**STAFF REPORT**  
CONCERNING APPLICATION FOR A  
**CERTIFICATE OF APPROPRIATENESS**

**Application Number:** 2018-0706

**Property Location:** 304 Twyckenham Drive

**APPLICATION ITEMS:** "Convert existing den on north side of the house (was originally an outdoor or screened porch) into a glass porch (see drawings and specifications). All new material to match existing exactly. Smooth cedar trim, cedar shingles all painted. Marvin windows and doors, see specs."

① New Glass Porch - North Elevation  
 $\frac{1}{4}'' = 1'-0''$

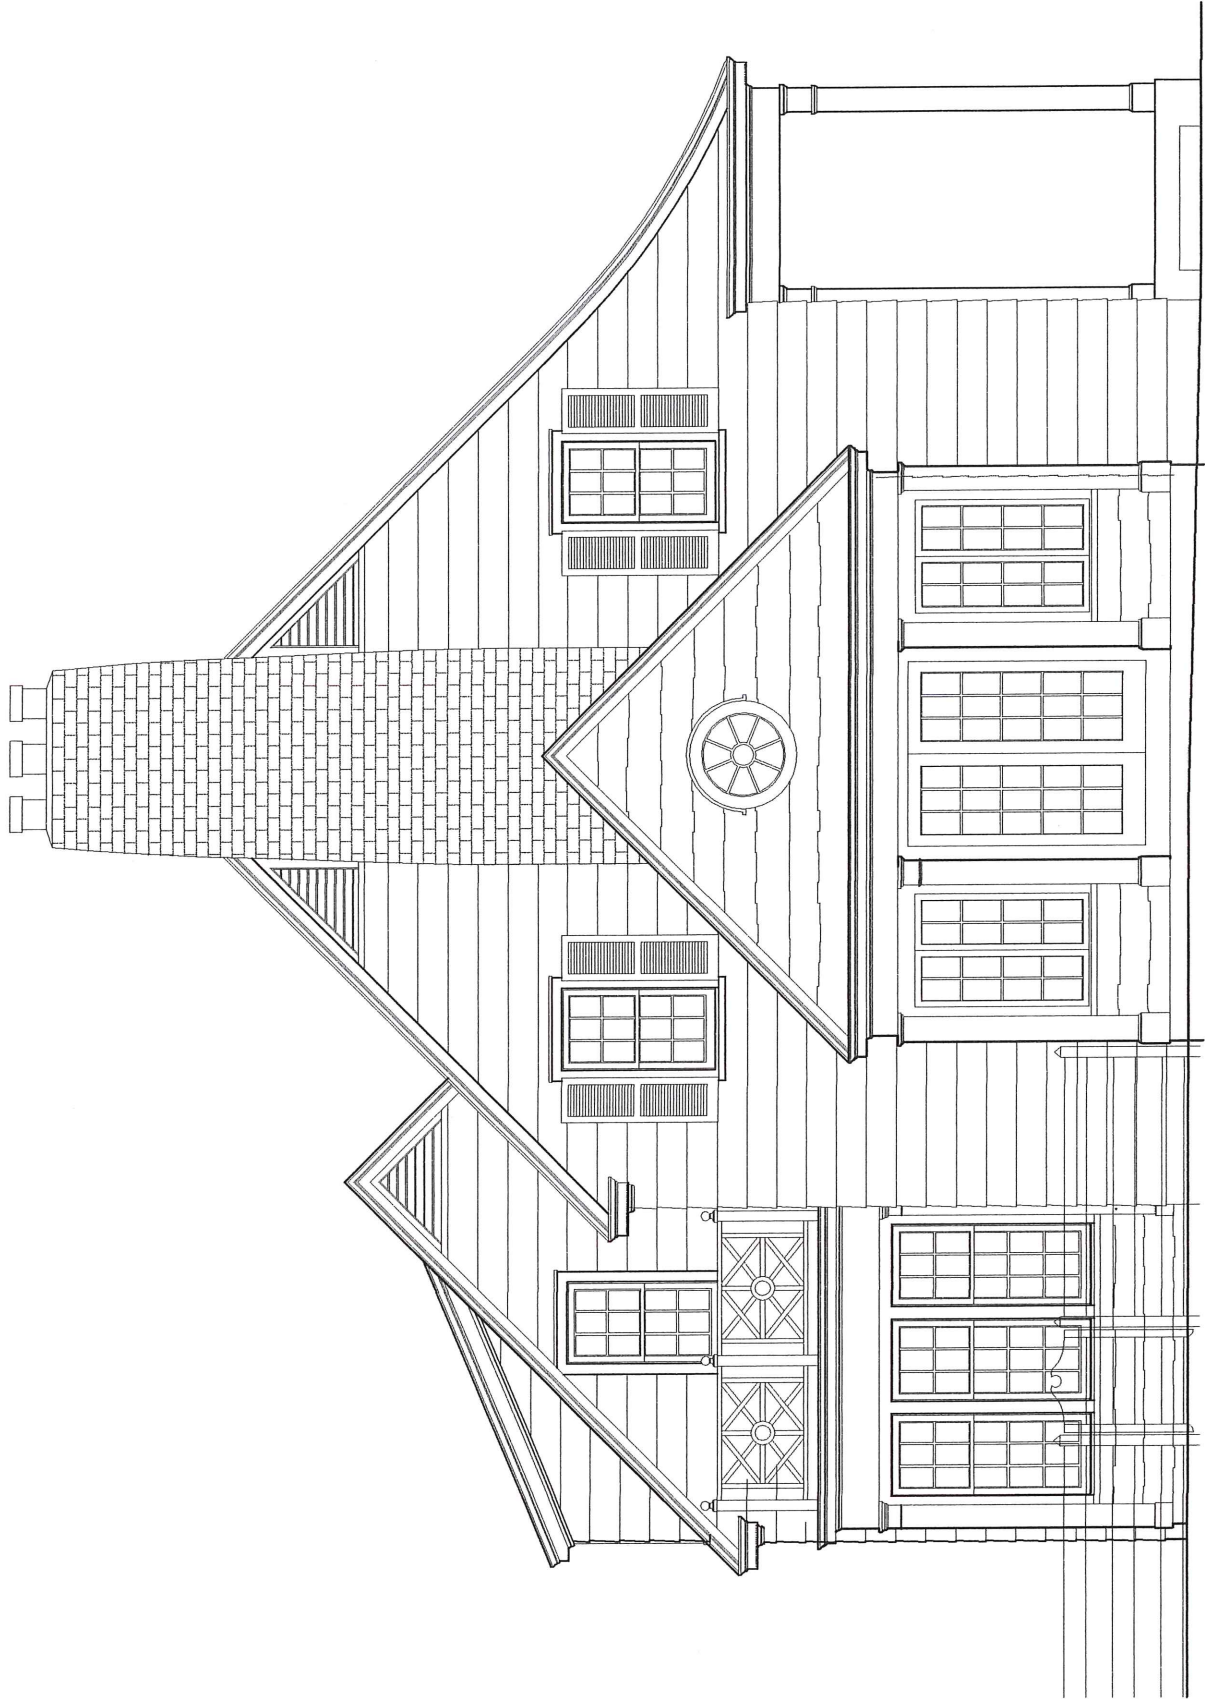
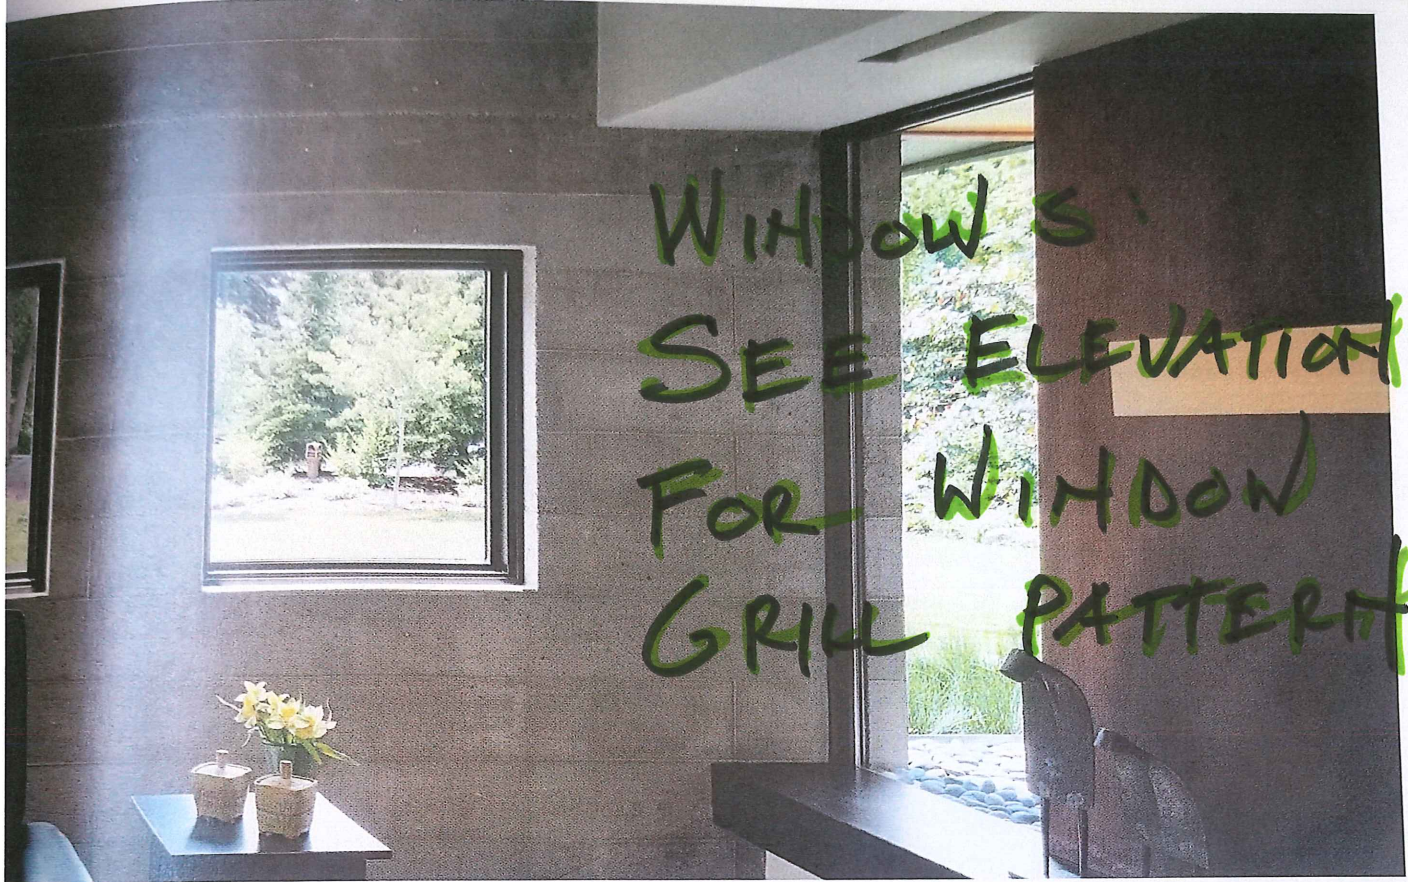
1. Conversion of an enclosed first floor room into a sun-room with exterior access by removing existing windows and installing the following:
  - a. West Elevation:
    - i. First story -
      1. Four Marvin Ultimate Casement windows with 12 simulated divided lights (with space bar);
  - b. East elevation:
    - i. First story –
      1. Four Marvin Ultimate Casement windows with 12 simulated divided lights (with space bar); this wall mirrors the west wall.
  - c. North elevation:
    - i. First story –
      1. Four Marvin Ultimate Casement windows with 8 simulated divided lights (with space bar);
      2. Marvin Inswing Ultimate series doors,

Staff recommends approval, as the project is attempting to rehabilitate the structure to be more in keeping with the original design, which was either a screened-in porch or an outdoor porch.
